APPLICATION NO.	FILING DATE	FIRST NAMED INVENTOR	ATTORNEY DOCKET NO.	CONFIRMATION NO.
10/563,338	01/03/2006	Louis Lagler	P/4631-14	8840
2352 7590 09/16/2011 OSTROLENK FABER LLP 1180 AVENUE OF THE AMERICAS NEW YORK, NY 10036-8403				
EXAMINER				
KIRSCH, ANDREW THOMAS				
ART UNIT		PAPER NUMBER		
3781				
MAIL DATE		DELIVERY MODE		
09/16/2011		PAPER

Office Action Summary**Application No.**

DETAILED ACTION

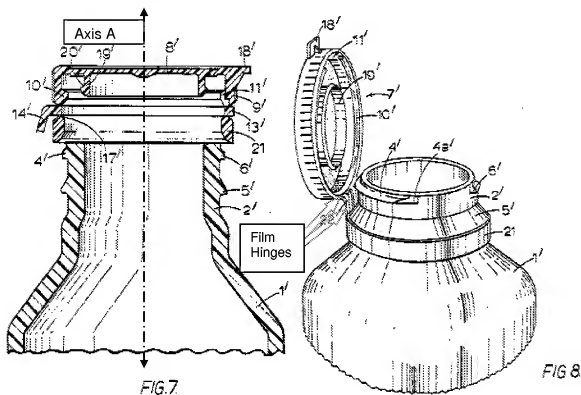
9. In re Claim 1, with reference to Figs. 7 and 8 below, Wheeler discloses: A closure moulded in closed position with

- a ring shaped body (21), the ring shaped body having an opening extending in an axial direction and having substantially the same diameter at both ends (see Fig. 7), comprising fixing means (17) to fix the closure on a neck (2') of a bottle (1'), the fixing means having substantially the same diameter as the opening (see Fig. 7), and

- a lid (7), the lid having substantially the same diameter as the ring shaped body (see fig. 7), the lid comprising a sealing means (19', 20') to seal an orifice (2') of the bottle, the sealing means directly contacting the neck of the bottle (column 3, lines 52-54), and

• a snap hinge comprising a first element (22) and a pair of film hinges (see Fig. 8) defining a plane, the pair of film hinges connecting the first element (22) to the lid (7) and to the body (21), whereby the plane is arranged substantially parallel to an axis A (Fig. 7) of the closure, the film hinges being defined on the outside by a cylindrical boundary surface having a radius R3 (at 21).

Fig. 7 of Rentsch et al.

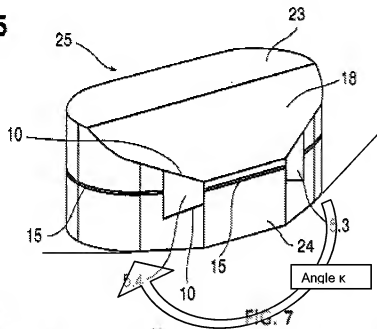
11. However, with reference to Figs. 6 and 7 below, Rentsch et al. discloses a closure wherein a snap hinge comprises a first and second trapezoid element (5.3, 5.4), and a second pair of film hinges (10) defining a second plane, and whereby the inside of each film hinge is defined by a plane (at 4.3 and 4.4) on the inside of the closure and the outside of the film hinge is defined by two flat boundary planes (at 5.3 and 5.4) arranged at an angle κ to each other.

22. In re Claim 6, with reference to the Figs. above, Wheeler in view of Rentsch et al. and Smith et al. discloses wherein the trapezoid elements (5.3, 5.4) are spaced apart by a cutout (see Fig. 5 of Rentsch et al.).

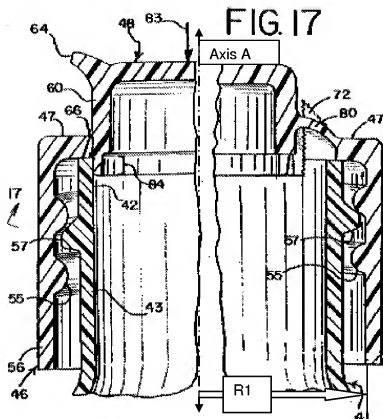
14. However, with reference to Fig. 17 below, Smith et al. discloses a one piece closure which is molded in the closed position in which the inner periphery of the film hinge (80) and an inner periphery of the closure (84) do not extend outward beyond a maximum inner radius R1 of the closure (see Fig. 17 below).
